APPROVAL <i>Slw</i>	REQUEST FOR Council ACTION	MEETING DATE 3/21/17
REPORTS AND RECOMMENDATIONS	Contract Ehlers, Inc. for financial services related to the use of tax increment financing in Area D, roughly between W. Oakwood and W. South County Line Roads and S. 27 th and S. 42 nd Streets.	ITEM NUMBER <i>G.6.</i>

**CITY OF FRANKLIN****REPORT TO THE PLAN COMMISSION**

Project Name:	Multi-Tenant Retail Building
Project Address:	6807 South 27 th Street
Applicant:	Steve Doran, Daybreak Capital, LLC
Property Owner:	WS Franklin LLC
Current Zoning:	Planned Development District No. 13, South 27 th Street Design Overlay District
2025 Comprehensive Plan	Commercial
Use of Surrounding Properties:	Wendy's, Walmart and Sam's Club to the north; Dental Associates and vacant land to the south; City of Oak Creek to the east; and Hobby Lobby to the west
Applicant Action Requested:	Recommendation of approval for the proposed Special Use and associated Site Plan for the multi-tenant retail building at 6807 S. 27 th Street.

Date: May 3, 2016
To: Brad Koning, Shulfer Architects, LLC
Victor Michel, WS Franklin, LLC
From: Department of City Development
RE: 6807 S. 27th Street Multi-tenant Building,
Speci

HOBBY LOBBY OUTLOT
SITE PLAN
FRANKLIN, WISCONSIN

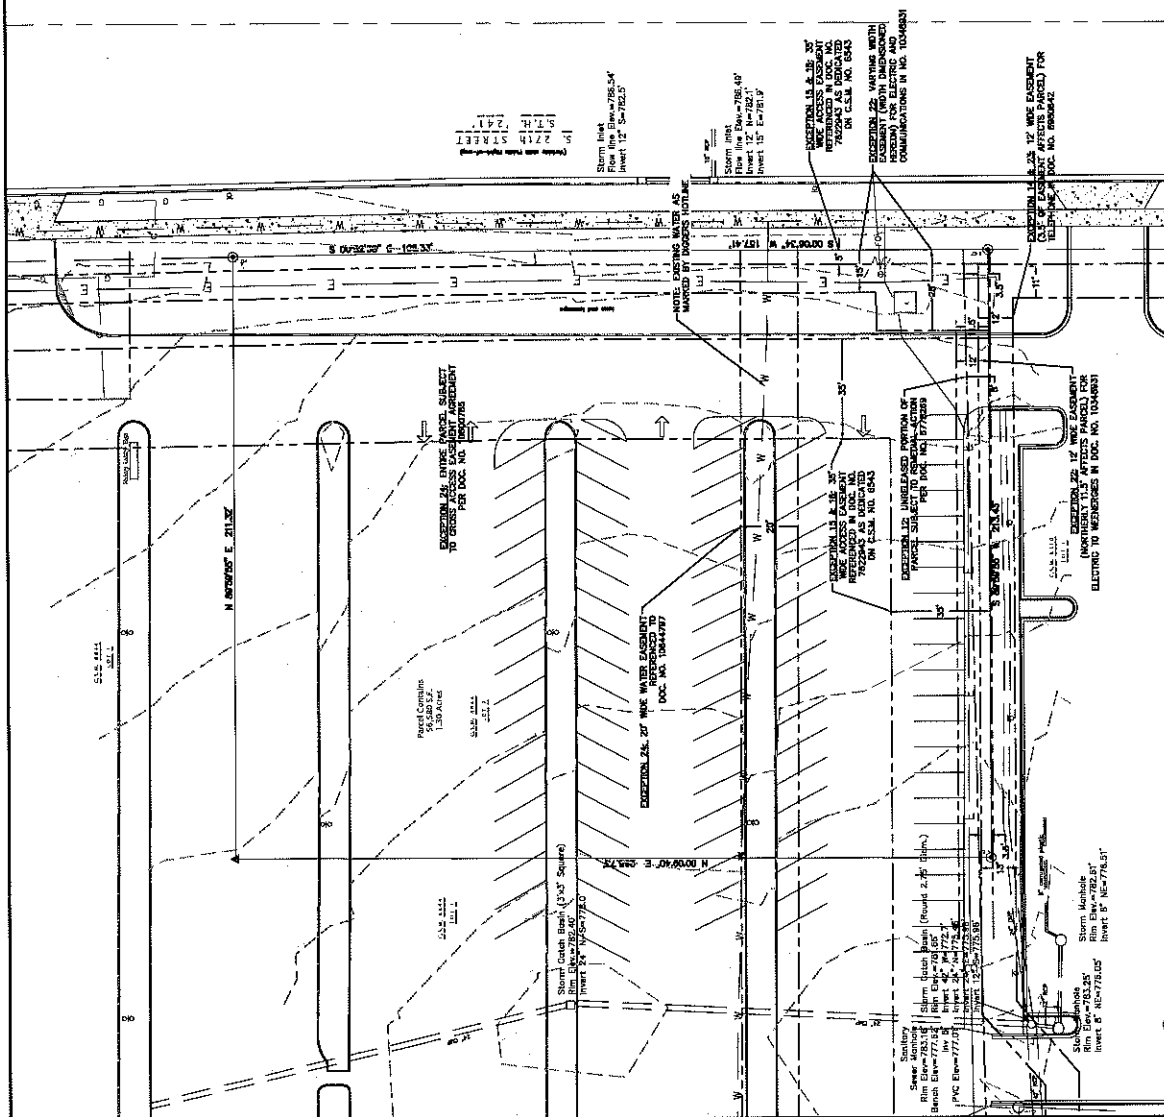
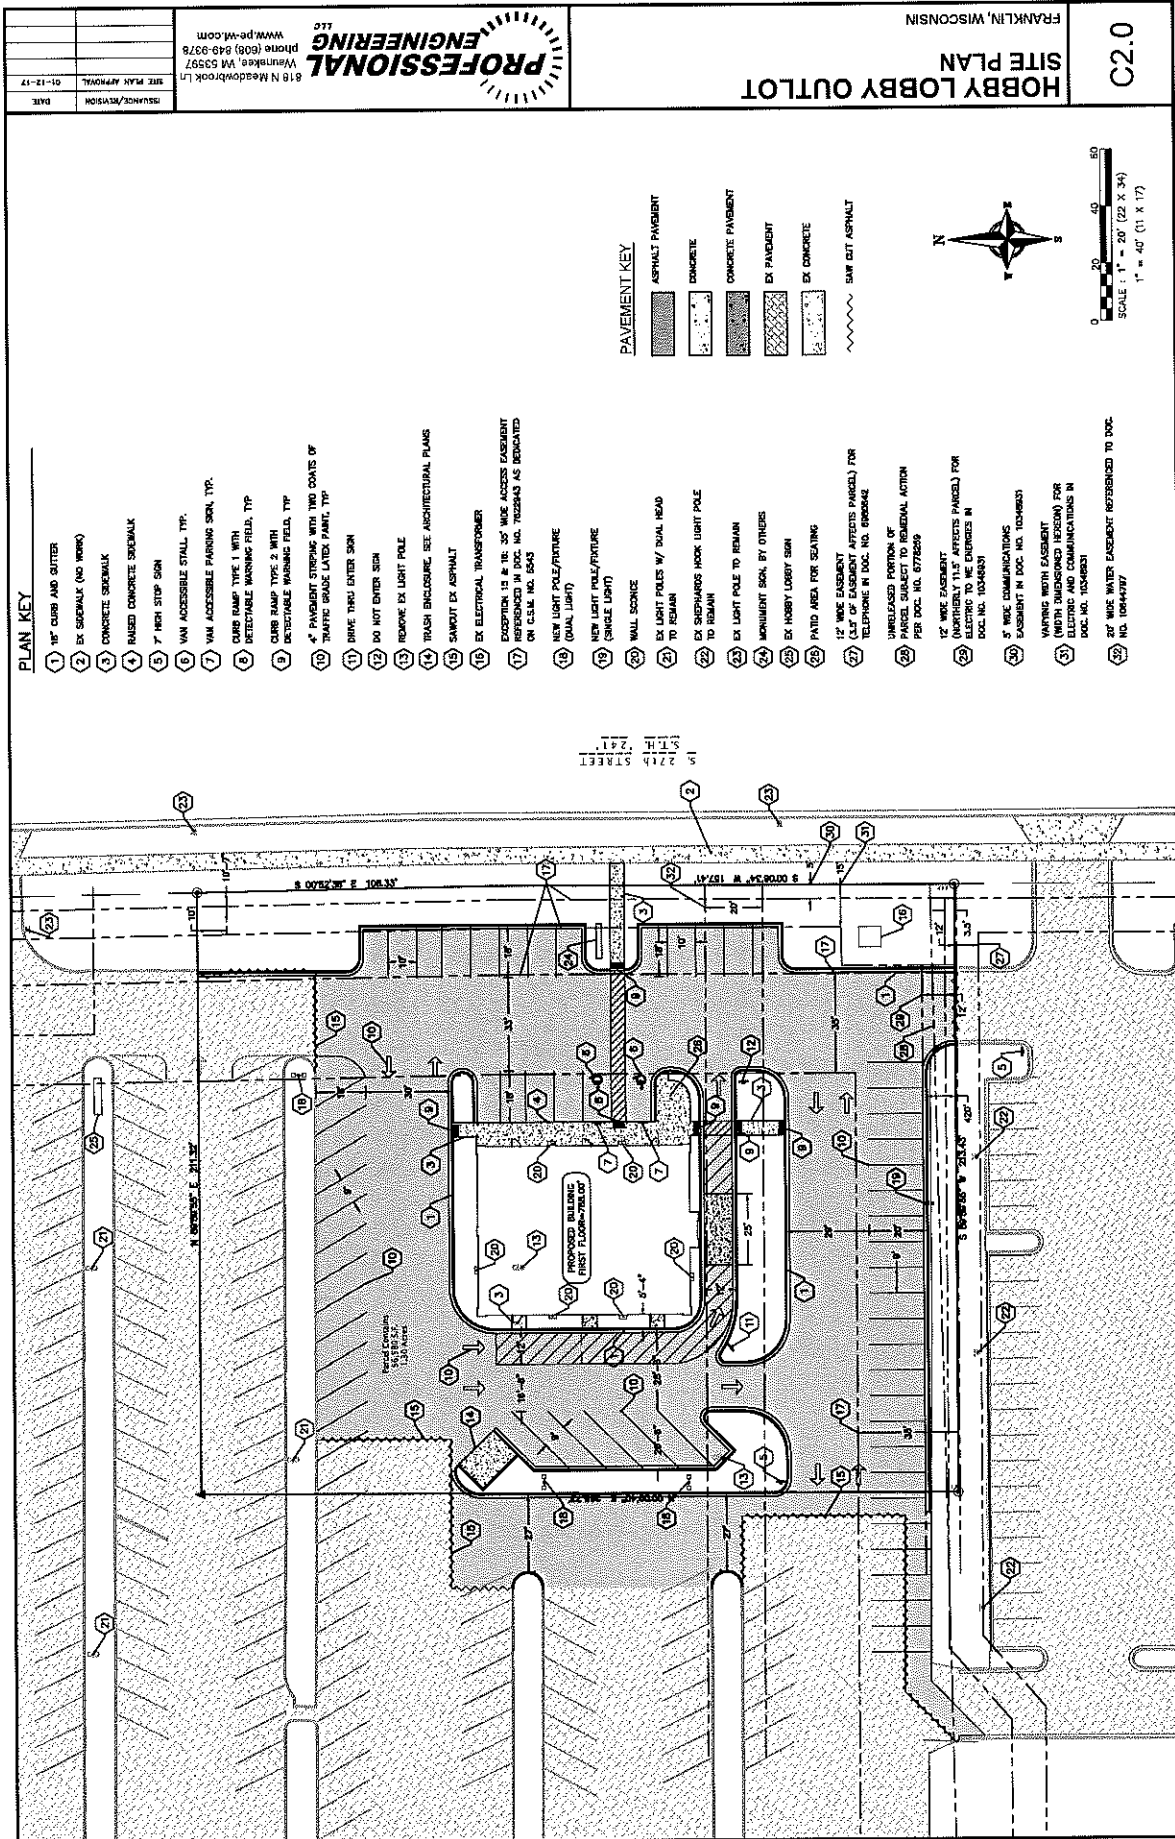
Although an outdoor seating area has been identified on the proposed plans, details about the site furnishings, pedestrian amenities, etc. have not been provided. Staff recommends that the applicant shall provide additional details about the outdoor seating area, including but not limited to site furnishings and pedestrian amenities, to the Department of City Development for review and approval prior to issuance of a Building Permit, and that such amenities be installed prior to issuance of an Occupancy Permit.

Neither a Snow Storage Plan, nor details about snow storage, have been provided by the applicant. Staff suggests that snow storage areas be identified on the Landscaping Plan for Department of City Development review and approval prior to issuance of a Building Permit.

PDD No. 13 states that the applicant shall provide the minimum off-street parking and loading as required by Section 14 of the City of Franklin Zoning Code (the City's zoning ordinance prior to the current Unified Development Ordinance). That section (as well as current UDO standards) require 45 parking stalls for the uses envisioned for the proposed retail building. The applicant indicates they are providing 55 parking spaces, however, a hand count of the parking spaces shown on the Site Plan and on the Landscape Plan indicate 68 parking spaces. This is 23 parking stalls, or about 51 percent more, than the required amount of parking. However, staff understands that currently, the entire subject parcel is part of a parking lot, and the applicant would like to retain the flexibility to potentially have a second restaurant at this location. Therefore, staff suggests that the applicant revise the Site Plan to remove such parking as to more closely match the amount required by PDD No. 13, and further suggests that the proposed new parking spaces along S. 27th Street be among the parking removed, for Department of City Development review and approval prior to issuance of a Building Permit.

HOBBY LOBBY OUTLOT GRADING PLAN

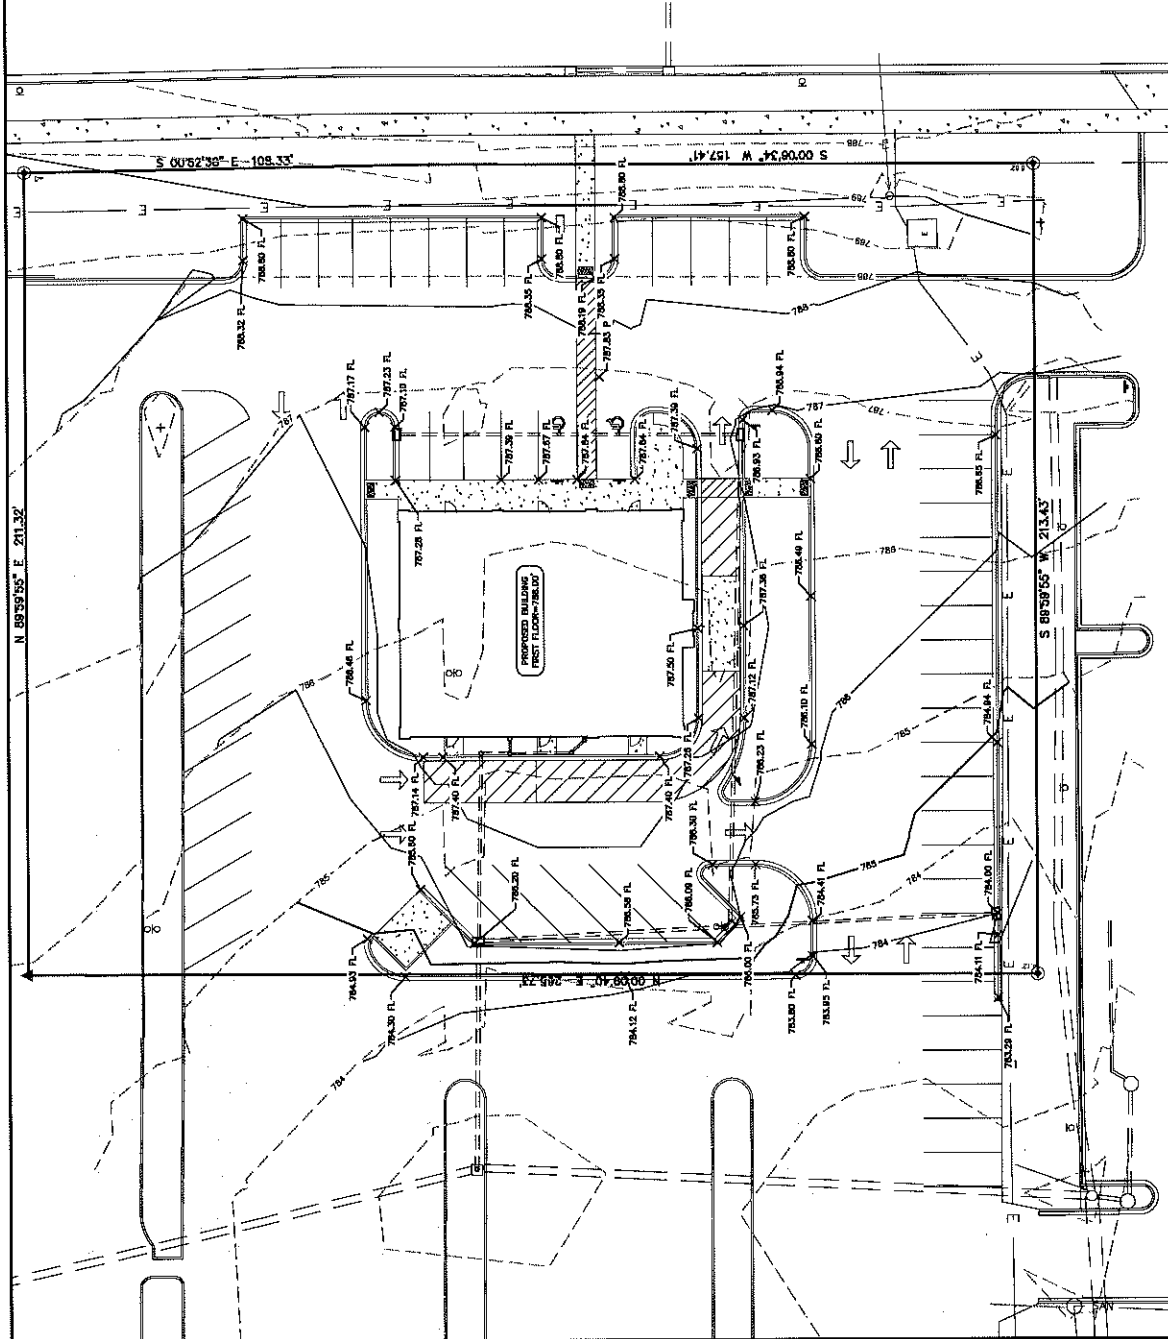
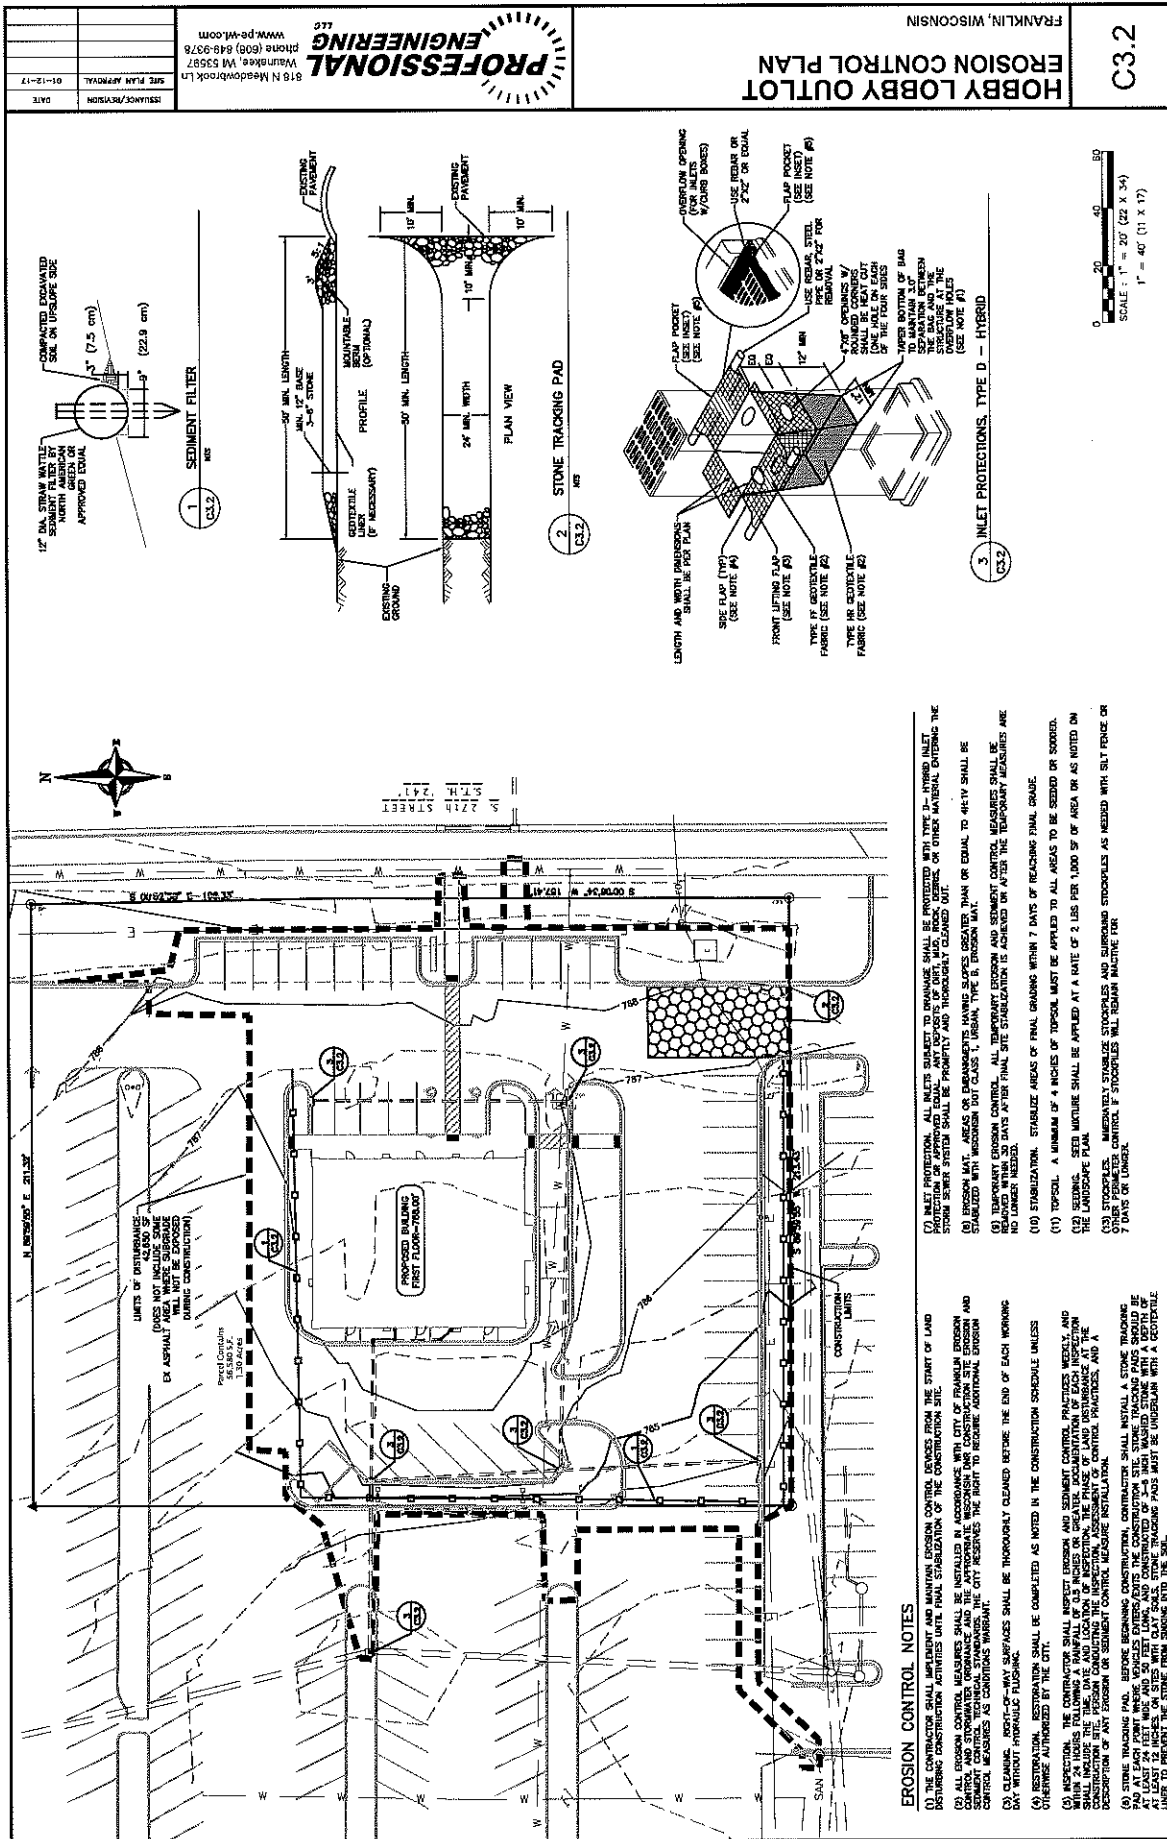
The development is entirely within the existing impervious surface area of the site. The applicant will be adding some greenspace as shown on the attached Erosion Control and Grading Plans. Pursuant to PDD No. 13, staff recommends that the grading, erosion control, and stormwater management plans shall be subject to review and approval by the City Engineer prior to issuance of a Building Permit.
